3	Redline No.3 Revised based on HDD comments	10-23-98
4	Redline No.4 Revised based on HDD comments	04-09-99
3	ADDENDUM 3 MARCH 5, 1998	
©	ADD PEDS AND REPLACE CABLE WITH STREETSCAPE PROJECT	11/97

MARYLAND DOT - STATE HIGHWAY ADMINISTRATION

TRAFFIC ENGINEERING DESIGN DIVISION

MD 924 (BOND STREET) @ MD 22 (CHURCHVILLE ROAD)

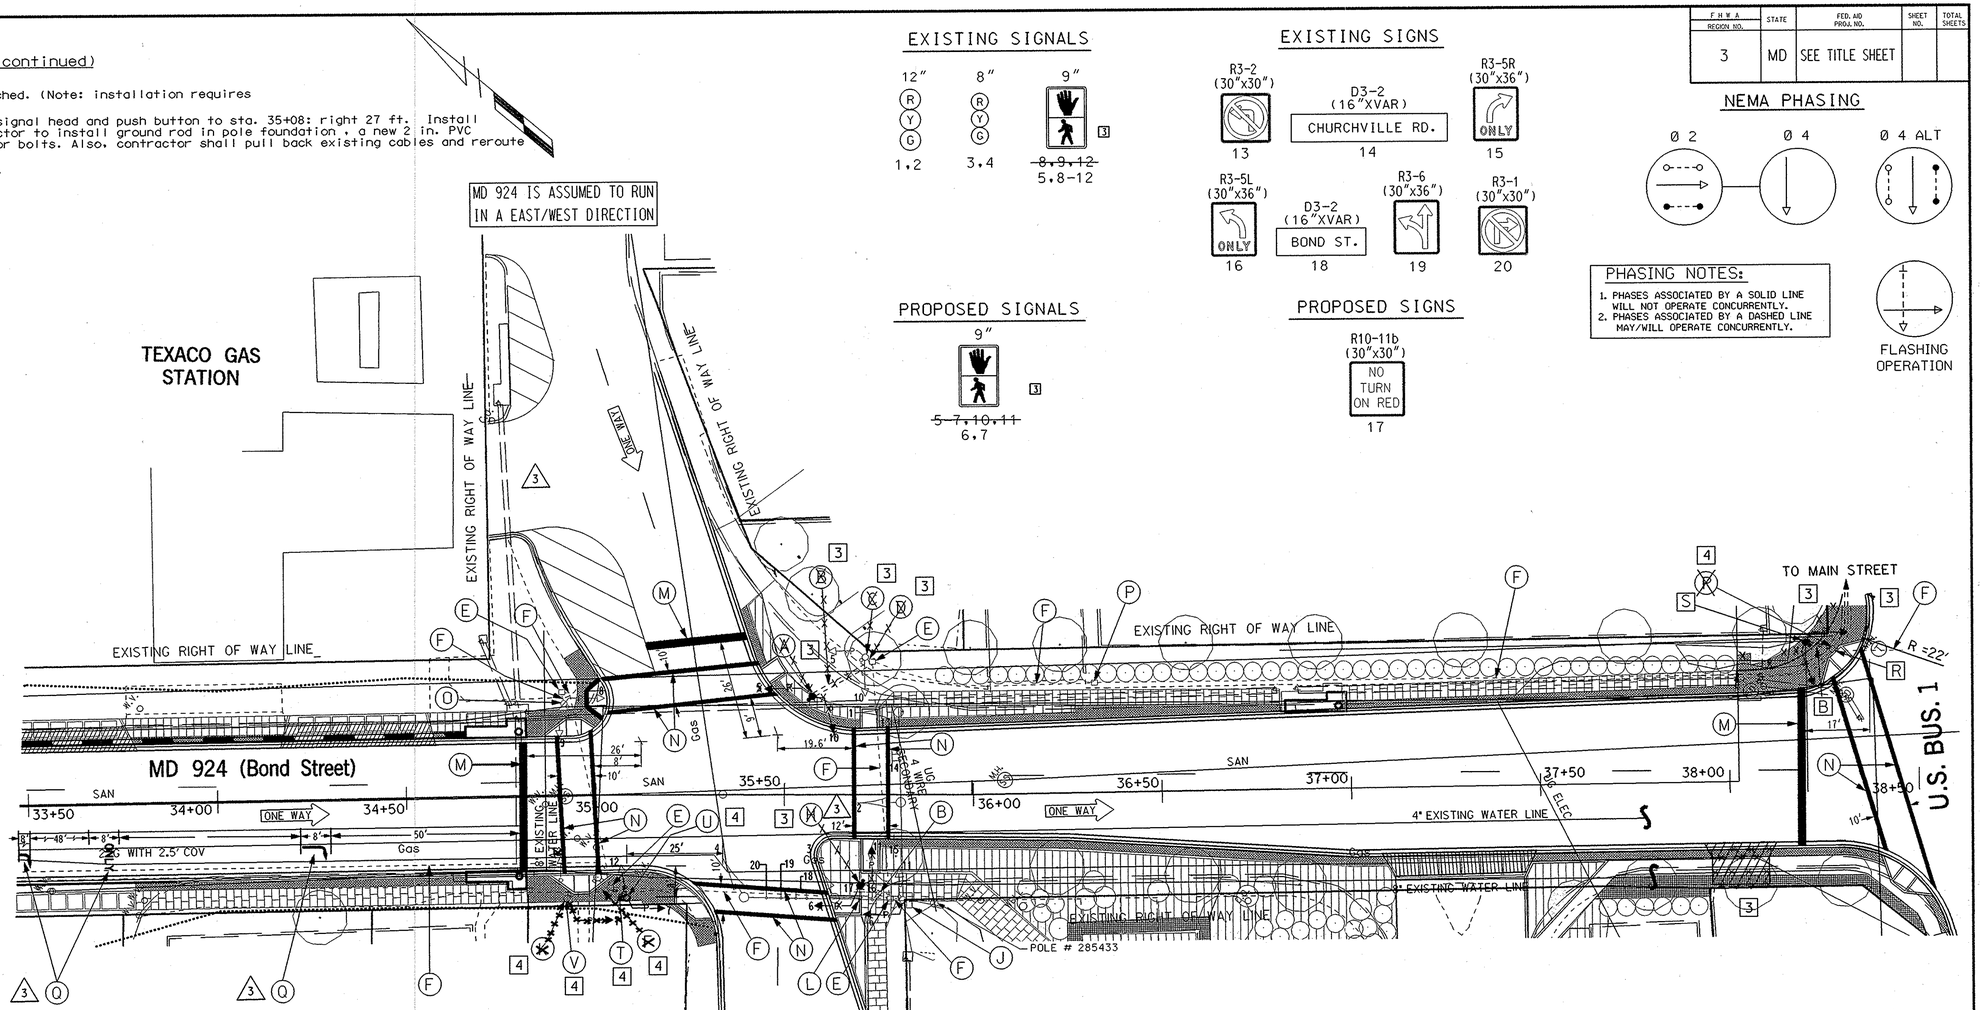
4 T. Install 2 in. PVC schedule 80 electrical conduit - trenched. (Note: installation requires the removal and replacement of existing sidewalk).

4 U. Relocate pedestal pole with breakaway base, pedestrian signal head and push button to sta. 35+08: right 27 ft. Install proposed pedestrian signal head, as shown. (Note: Contractor to install ground rod in pole foundation , a new 2 in. PVC schedule 80 conduit bend and four - 1 in. x 40 in. anchor bolts. Also, contractor shall pull back existing cables and reroute to relocated pedestal pole.)

4 V. Existing pole to be relocated to sta. 35+08: right 27 ft.

12" R Y G 1,2 — 8" R Y G 3,4 — 9" 3 ~~8,9,12~~ 5,8-12

9" 3 ~~5,7,10,11~~ 6,7

3 A. ~~Install 10 ft. pedestal pole with breakaway base, signal heads and pedestrian push button at sta. 35+57: left 26 ft. (Note: One - 2 in. PVC schedule 80 conduit bend and four - 1 in. x 40 in. anchor bolts. Also, install ground rod in pole foundation.)~~

3 G. DELETED

3 H. ~~Install 10 ft. pedestal pole with breakaway base, signal heads, and~~ push button at sta. 35+70: right 24 ft. (Note: one - 2 in. PVC schedule 80 conduit bend and four - 1 in. x 40 in. anchor bolts. Also, install ground rod in pole foundation). Also, install pedestrian signal head as shown.

3 M. Install 24 in. white thermoplastic pavement marking tape.

3 N. Install 12 in. white thermoplastic pavement marking tape.

4 ~~P. Use/adjust existing handhole to final grade.~~

3 Q. INSTALL PERMANENT PREFORMED PAVEMENT MARKING LETTER AND/OR ARROW AS SHOWN.

3 R. Adjust exiting handhole to final grade and install ground rod.

3 S. Install 10 ft. pedestal pole with breakaway base, signal heads and pedestrian push button at sta. 38+20.5: left 37 ft. (Note: One - 2 in. PVC schedule 80 conduit bend and four - 1 in. x 40 in. anchor bolts).
